Backfeed v261

v261 Excluded 0 to 10.1V range from the PSE I_{rev} requirement, various rewordings to add clarity.

145.2.4 PSE PI

Figure 145–27a — Detection signature requirements connection configurations

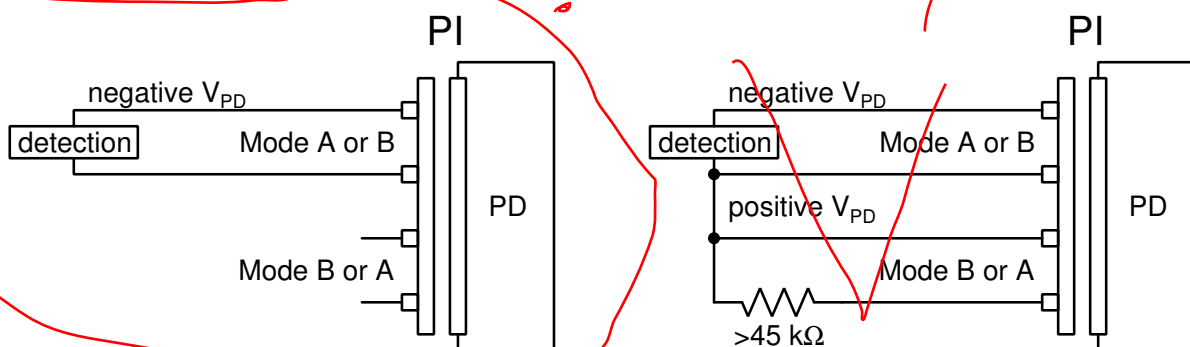
When a PD presents a valid or non-valid detection signature, it shall present the detection signature on each pairset, when probed per any of the valid 2-pair configurations defined in Table 145–20. In addition, one pair denoted with “—”, is connected to the positive potential with any series resistance greater than 45 k Ω (see Figure 145–27a).

Add new Figure 145–27a as follows:

Figure 145–29a — Reflected voltage requirements

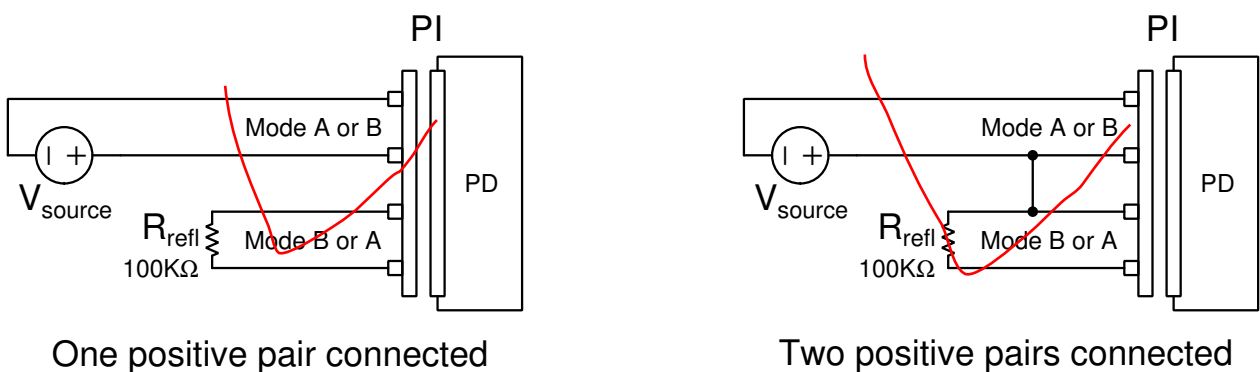
For a single-signature PD, when any voltage in the range of 0 V to V_{Port_PD-2P} max is applied per any of the valid 2-pair configurations, defined in Table 145–20, that have only a single pair connected to positive V_{PSE} (see Figure 145–29a), the voltage on the Mode not connected to the voltage source, with a 100 k Ω resistor connected across that Mode, shall not exceed V_{refl} as defined in Table 145–29.

For a dual-signature PD, when any voltage in the range of 0 V to V_{Port_PD-2P} max is applied per any of the valid 2-pair configurations, defined in Table 145–20, including those with two pairs connected to positive V_{PSE} (see Figure 145–29a), the voltage on the Mode with at least one pair not connected to the voltage source, with a 100 k Ω resistor connected across that Mode, shall not exceed V_{refl} as defined in Table 145–29.
